Work Order ID 86975

Item Name: Plate

DRAWING NO. D3303	TITLE HEAD REST	REV. B	DART AEROSPACE LTD ENGINEERING ORDER		D.E.O. NO. D3303-B-1	SHEET NO. SHEET 1 OF 1	SCALE NTS
DRAWN AJS	CHECKED <i>h</i>	MFG. APPR. <i>h</i>	APPROVED <i>h</i>		DE APPR. <i>h</i>		
DATE 08.10.15	DATE <i>08.10.15</i>	DATE <i>08/10/16</i>	DATE <i>08/10/16</i>		DATE <i>08/10/16</i>

**D3303-041 HEAD REST**

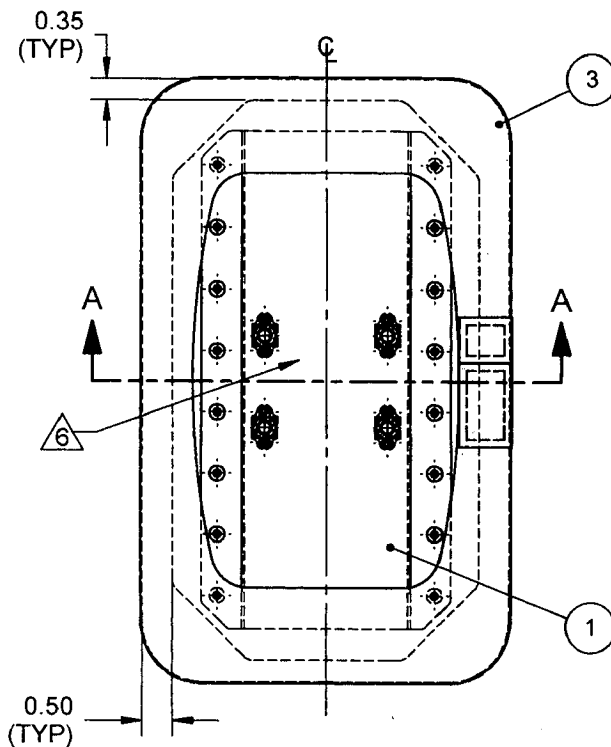
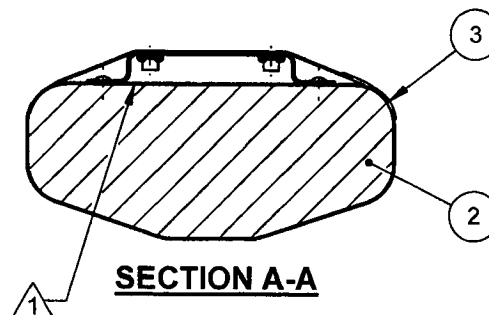
SHEET 1 ADD 1300L ADHESIVE BY 3M TO NOTE 1 AS FOLLOWS:

WAS:

- 1) BOND D3305-1 FOAM TO D3303-043 BRACKET ASSEMBLY USING 3M 1300 ADHESIVE (0.002" TO 0.010" THICK) IN ACCORDANCE WITH MANUFACTURER'S INSTRUCTIONS

SEE NCR 08-069 FOR FURTHER DETAILS

IS:

- 1) BOND D3305-1 FOAM TO D3303-043 BRACKET ASSEMBLY USING 3M 1300 OR 1300L ADHESIVE (0.002" TO 0.010" THICK) IN ACCORDANCE WITH MANUFACTURER'S INSTRUCTIONS
